VILLAGE OF HOMEWOOD

MEMORANDUM

Topic: Case 24-07: Upham Subdivision (Brunswick Zone)

Figure 1. Proposed Resubdivision (outline in yellow), as located on land use map from West 183rd Street TIF Proposal (prepared by Christopher B. Burke Engineering LTD).

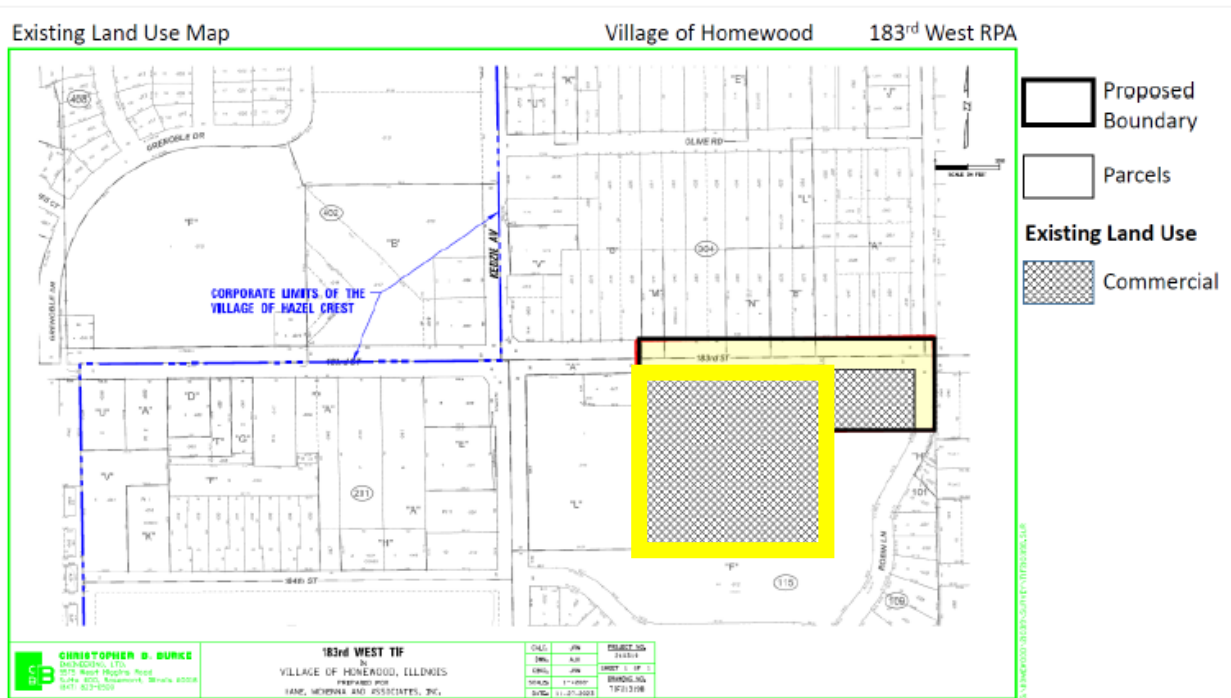
The resubdivision plat proposes that the existing property (PIN: 31-01-100-012) be split into four parcels, to create two outlots abutting 183rd Street and a separate lot for the Village’s pump station. This subdivision will support the creation of additional commercial buildings in the large parking field in front of the existing building. Appropriate easements for parcel cross-access, sewer, and stormwater drainage are proposed to support the scale of commercial development. Proposed easements and planned utilities are sufficient for the proposed development and are compliant with Section 36 of the Village of Homewood Code of Ordinances.
